**Reference: RESPONSE LETTER- "NOTICE OF DISAPPROVAL",
"CLEANUP STATUS FOR API SEPARATOR OVERFLOWS"
(SEPTEMBER 5, 2009 and DECEMBER 8, 2009)
WESTERN REFINING SOUTHWEST INC, GALLUP REFINERY
EPA ID NO. NMD000333211
HWB-GRCC-MISC**

Interim Measures Work Plan
WESTERN REFINING SOUTHWEST, INC., GALLUP REFINERY
EPA ID #NMD000333211
April 2010

FIGURE 1

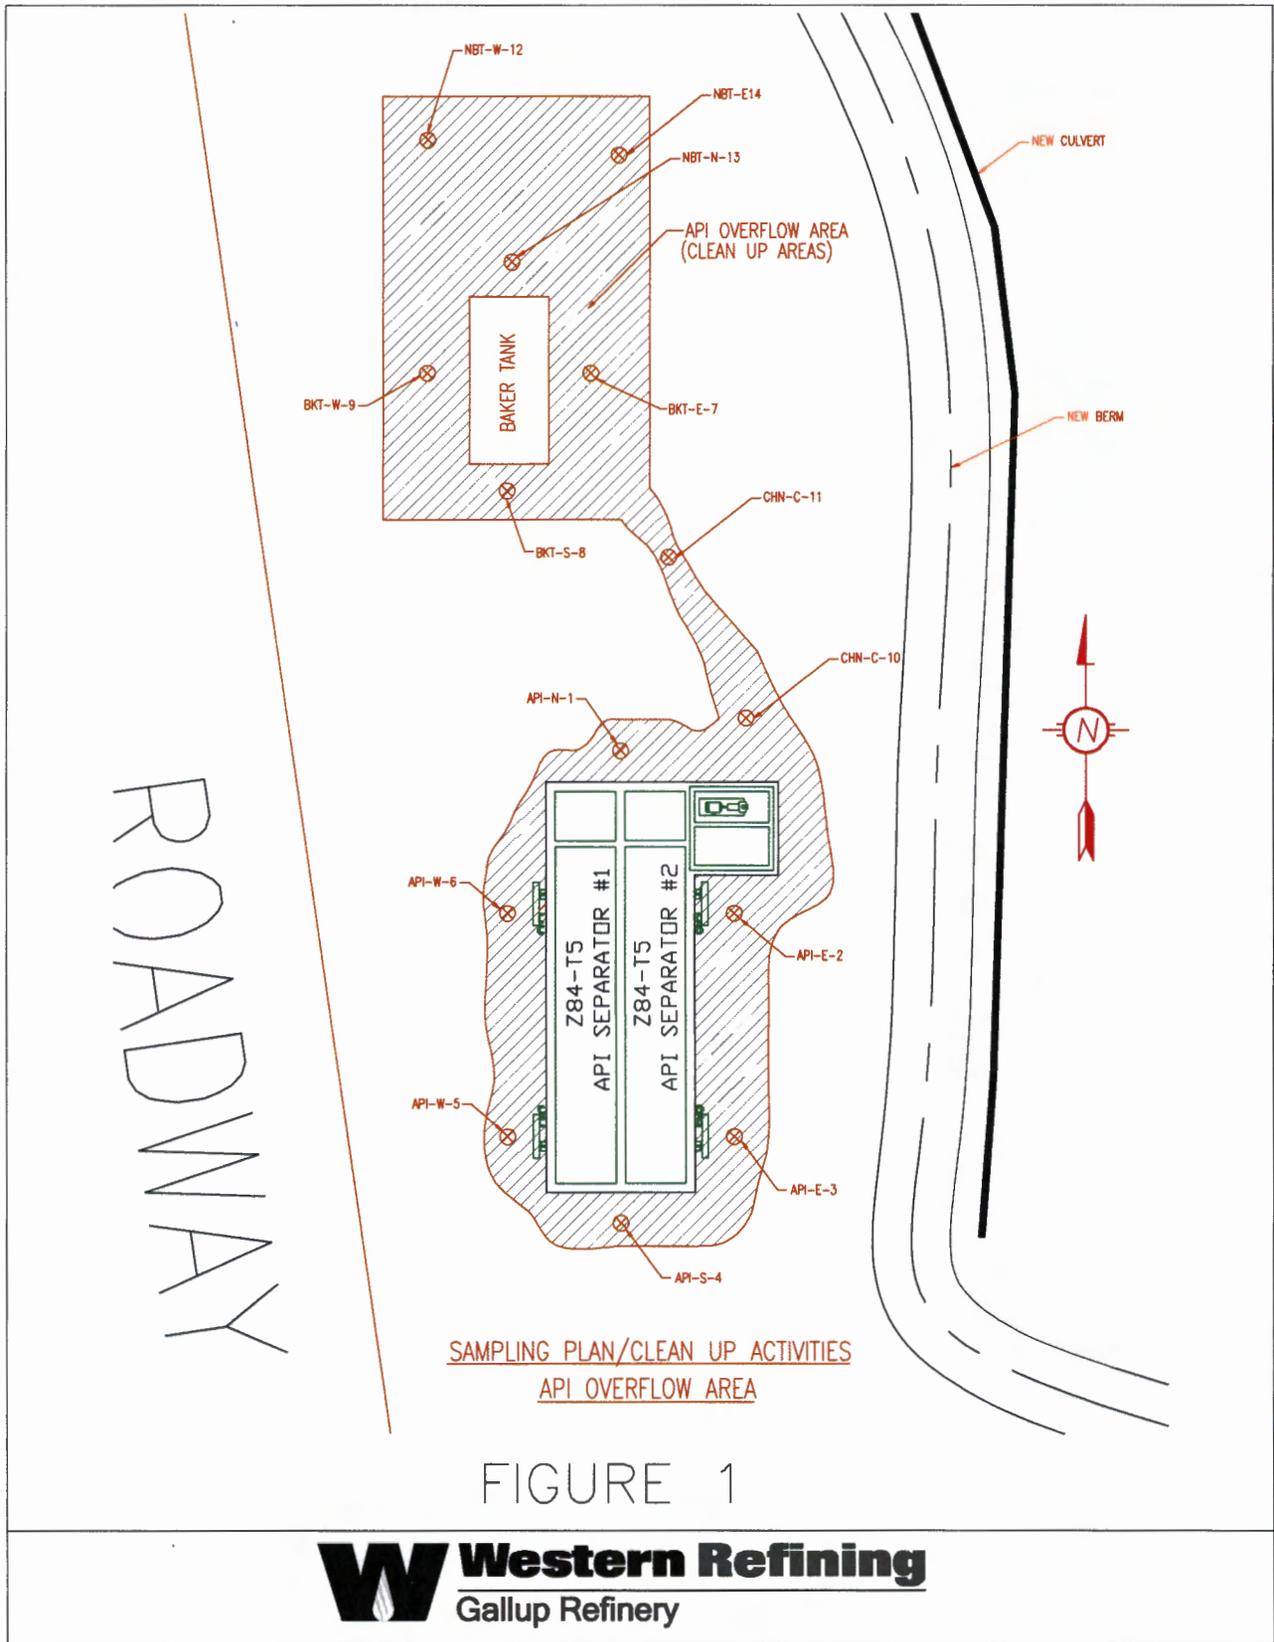
I. COMMENT 1-"Permittee must describe in detail the sampling collection methods and procedures that were used to collect the confirmation samples (eg., how were the samples collected, were they discrete or composite samples, how were any composite samples collected, what equipment was used (shovel, encore sampler) to collect the samples). The Permittee must also describe the decontamination process of the sampling equipment (eg., equipment was cleaned in a non-phosphate solution followed by a rinse using de-ionized water."

III. COMMENT 3-The Permittee must address the following regarding the “Confirmation Samples” figure that identifies the areas requiring additional excavation and confirmation sampling.

- a. **The figure shows two hatched areas: the blue hatch identifies the “Area of Possible Contamination” and the red hatch identifies that the “Area is Contaminated.” The report indicates that the red hatch area is where additional excavation and confirmation sampling will occur. The Permittee must explain the difference between the red and blue hatch areas, and specifically why the “Area of Possible Contamination” does not require additional sampling.”**

- b. The area west of the Baker Tank is hatched, red indicating that additional excavation and confirmation sampling will occur; however, there are two small areas within the red hatch that are blue (west edge of the excavation and the southwest corner edge of the excavation), an area which indicates no further sampling will be conducted. It is not clear how the Permittee determined that these “blue” areas do not need additional excavation and sampling. Additionally, it is unclear how the Permittee determined the areas north and south of the sample location API-W-6 do not need additional excavation. The Permittee must explain how the borders between the “Area of Possible Contamination” and the “Area is Contaminated” were determined.**

- a. Sample Collection- Six inches of soil was removed at each of the fourteen (14) sample locations using a stainless steel (6") garden spade. Fourteen (14) discrete samples were

- collected in individual 8 oz glass jars at the indicated sample collection point locations as indicated on the initial Sampling Plan. (Figure 1)
- b. Sampling Equipment-A clean stainless steel (6 inch) garden spade was used to collect each sample. The sampler used clean latex gloves in order to minimize any cross contamination that may occur during the sampling event. After collecting an individual sample and before collecting the next sample, the latex gloves were replaced with a new pair of latex gloves.
 - c. Decontamination Process or Procedures- The spade was decontaminated before and after each sample collection using an Alconox solution or Simple Green cleaner followed by a de-ionized water rinse.

RESPONSE: The “Red” hatch (Area is Contaminated) and the BLUE hatch (area of Possible Contamination) was based on the Total Petroleum Hydrocarbon (TPH) values greater than 200 mg/kg as determined from 2006 (2009) Soil Screening Levels (SSL). Areas that were greater than 200 mg/kg were considered to be a “HOT ZONE”, i.e., shaded in “RED” hatch or “Area is Contaminated”. Areas that were less than 200 mg/kg was considered to be “BLUE” hatch or “Area of Possible Contamination” Clean up efforts will be made for both “RED” and “BLUE” hatch areas. These areas do not determine if excavation is required, only which areas are more contaminated than others.

RESPONSE: The two small areas of concern are due to a drawing error. These two areas are all considered as contaminated, should have been identified as a red hatch area, and will also be excavated. Excavation and sampling of the areas north and south of the sample location API-W-6 will also be performed. A detailed description of the red and blue hatch areas was previously identified under comment (3 a) above.

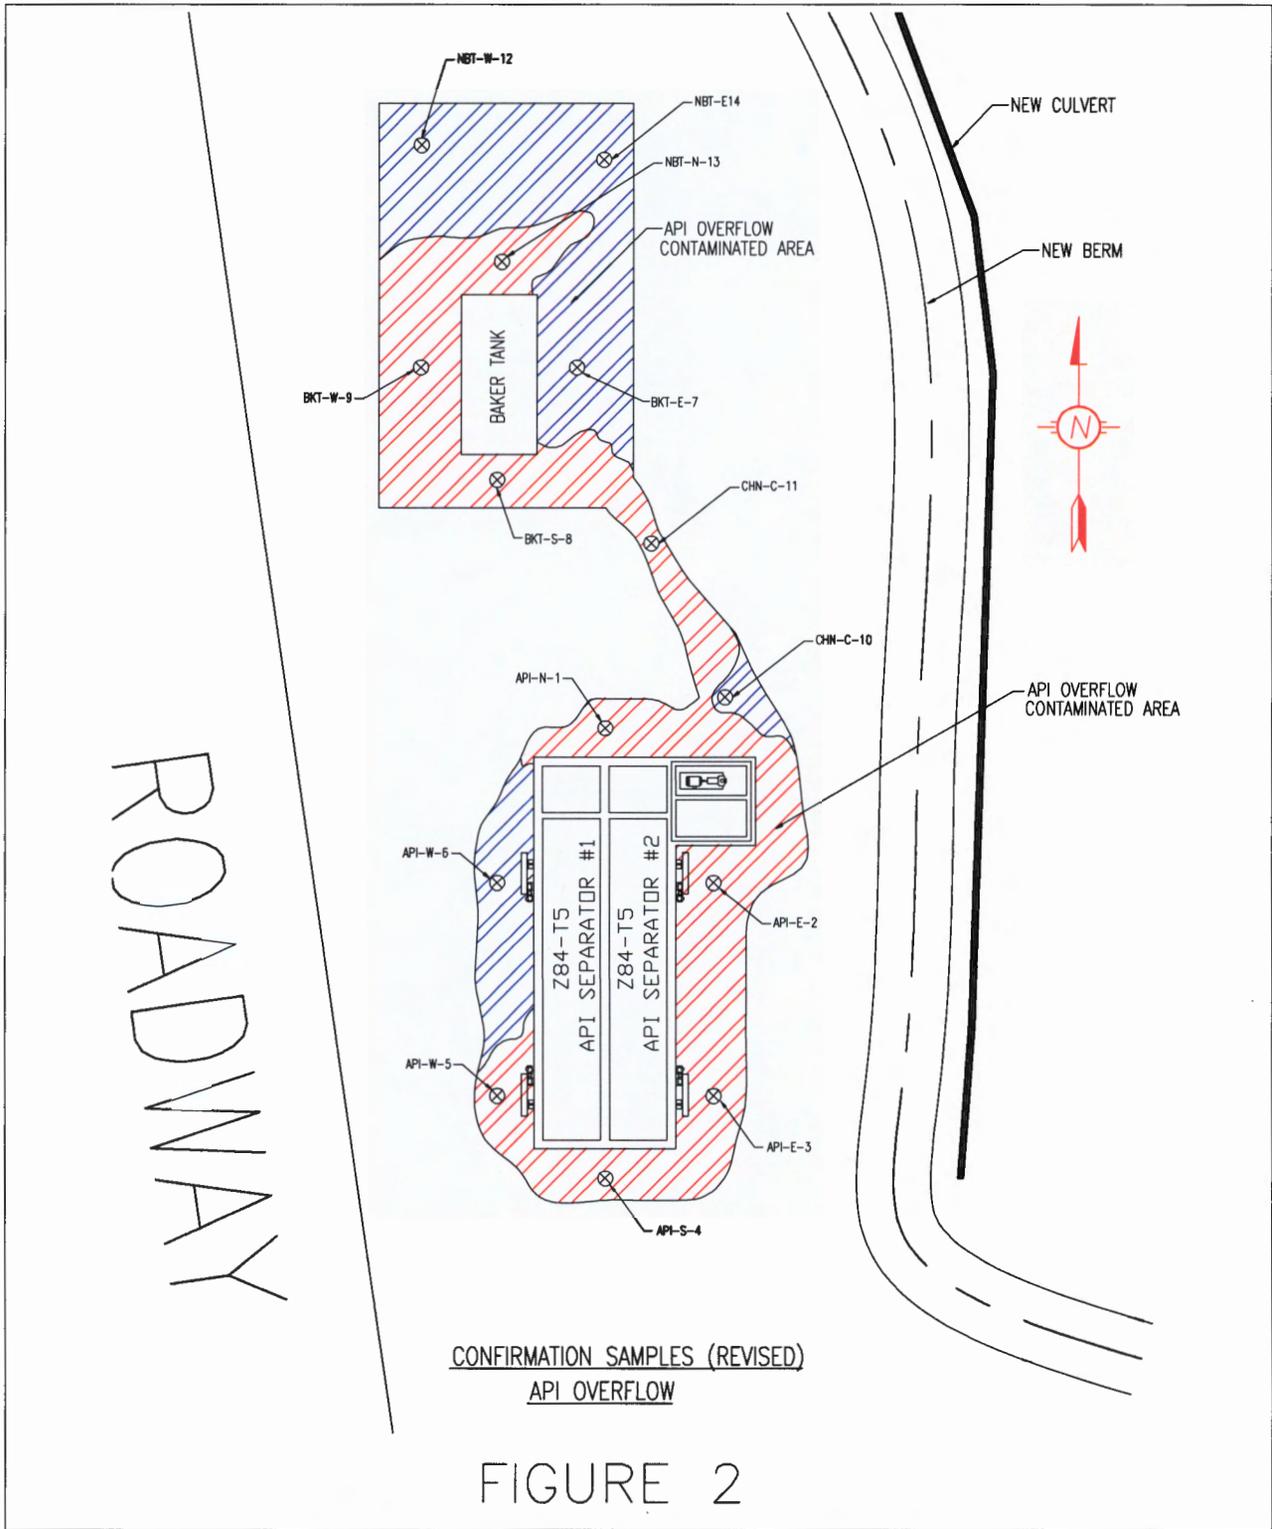
- c. Additional sampling is necessary to define the horizontal and vertical extent of contamination in areas where contaminants are still present. The Permittee must revise the Confirmation Sampling figure to address items a and b and propose additional sampling. The Permittee must be able to demonstrate that clean up of contamination surrounding the API separator and Baker Tank has been completed.**

RESPONSE: The facility is in process of addressing the API overflow issue which is the cause of the contamination. An “Interim Measures Work Plan” is being submitted along with this report. This plan addresses the API overflow issues in more detail. Additional excavation and sampling will be conducted around the API and Baker Tanks both under the “BLUE” and “RED” hatch areas. (Figure 2)

Appendix B: API Area Drawing with Newly Installed Baker Frac Tanks

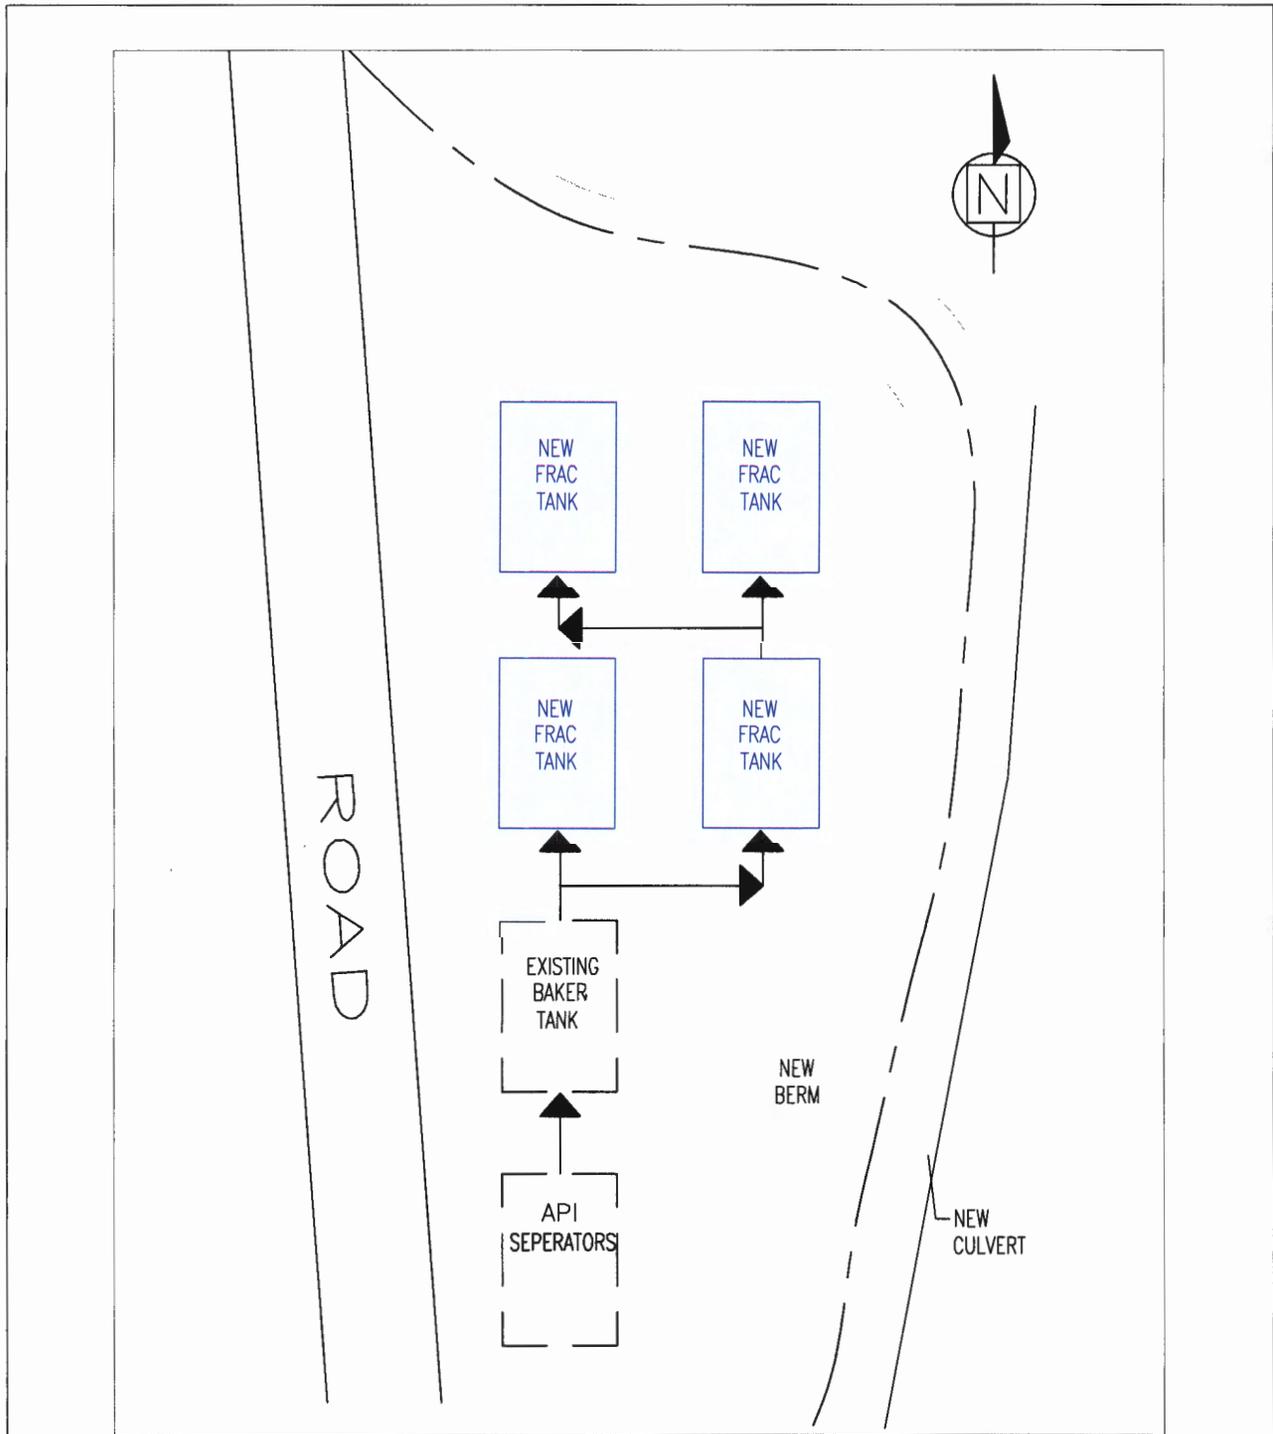
IV. COMMENT 4- In NMED’s September 15, 2009 letter regarding the Formal Report submittal to the September 5, 2009 API Separator Overflow, NMED directed the Permittee to provide steps that would be implemented to ensure overflow to the API separator do not continue to occur. On page 5 of the Report, the Permittee states “both of the API overflows were the direct result of inclement weather conditions that were beyond the control of the refinery. Gallup is in the design phase of a new “Stormwater Diversion Project” in order to eliminate overflows from the new API due to unexpected or inundated

The overflows were a direct result of the weather, which cannot be controlled by the Permittee; however, the Permittee can control how the overflows are handled so that the wastewater will not flow to the ground surface. The Stormwater diversion Project is not yet installed. Until it is, the API separator must prevent releases from the API separator to the ground surface. The Permittee must propose an interim measures in accordance with Section IV.B.6 (Interim Measure (IM)) of the Post-Closure Care Permit that will control and prevent all overflow from the API separator to the ground surface until the Stormwater diversion Project is installed and operational. The Interim Measures Work Plan is due to NMED on or before April 19, 2010.

RESPONSE: An "Interim Measures Work Plan for control and prevention of Overflow from the API Separator" has been prepared. The plan discusses the amendments to the API area through the use of four (4) additional frac tanks in conjunction with an existing frac tank. The Interim Measures Work Plan is being submitted in conjunction with this report. (Attachment)

The existing frac tank (500 bbls) is connected to the new API separator. This tank collects overflow liquids from the API due to excess flow from the process units. The only design change to this set up is to add four (4) additional frac tanks (500 bbls each) to the existing system. The importance of this as the first step is to be able to handle any API overflows in order to assure that this will not occur. Tank installation has to be the first step because any API overflow will cause additional contamination in this same area that we are trying to remediate. Dirt Work has to be done to insure a solid foundation for the baker tanks. The dirt work and frac tank installation will be on a non-contaminated area north of the existing baker tank. Next, Piping has to be fabricated. Baker Tanks Co has to deliver four (4) frac tanks to this location. Piping will then have to be connected to each frac tank.
